SUBJECT: INSPECTION AND REWORK OF 0-360 & 10-360  
TUBULAR ENGINE MOUNTS.

MODELS AFFECTED: All Mooney M20C,D,E,F up to M20C S/N 680001,  
M20D S/N 261, M20E S/N 690001 & M20F S/N 680210.

ENGINE MOUNT - TYPICAL ALL MODELS  
SCALE: NONE  
ALL TOLERANCES  $\pm .03$

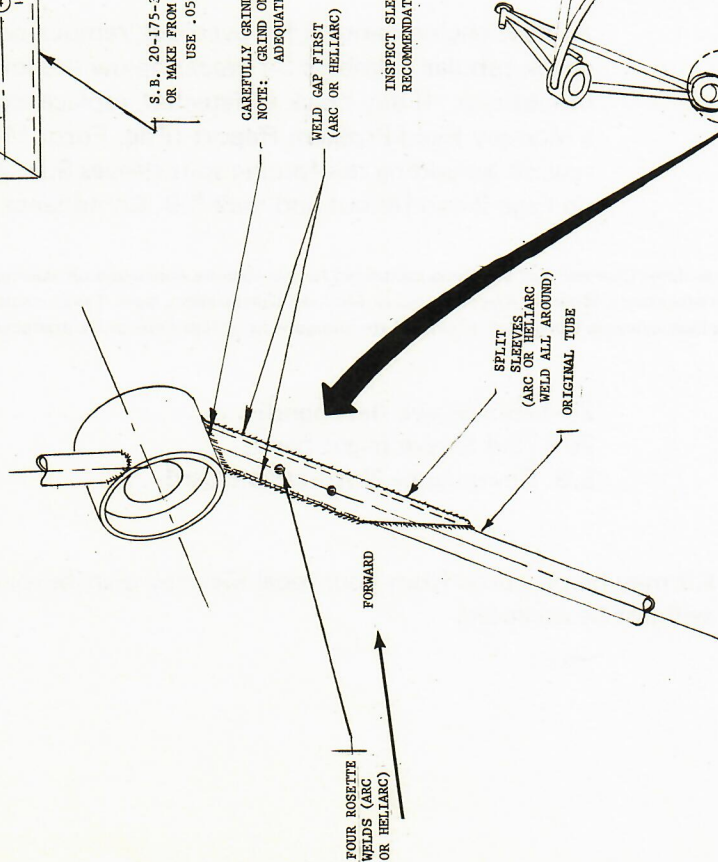
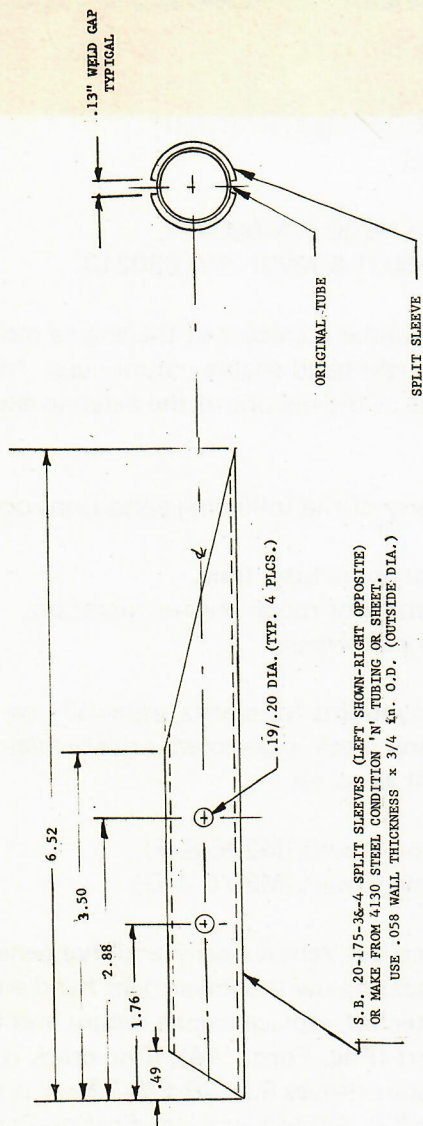
INTRODUCTION: There have been reports that tubular members of the engine mounts  
have cracked below the lower right hand engine mount cups. Installing  
a new reinforced engine mount or the rework of the existing engine  
mount is recommended.

INSTRUCTIONS: Visually inspect tubular engine mounts for cracks, especially below  
lower engine mount cups. If any crack is detected, replace engine mount  
with a reinforced engine mount as noted:

At next engine removal for overhaul, remove paint and dye penetrant  
check tubular members for cracks below the lower right hand engine  
mount cup. If any crack is detected, replace engine mount and fill out  
a Mooney Field Problem Report (Eng. Form 114); if no crack is found,  
rework by adding reinforcing split sleeves S.B. 20-175-3 & -4 as shown  
on Page 2 and fill out and mail S.B. Compliance Notification Card.

INSPECT SLEEVE AND MOUNT, AND WELD IN ACCORDANCE WITH  
RECOMMENDATIONS SET FORTH IN AC-43.13-1 CHAPTER 2, SECTION 2
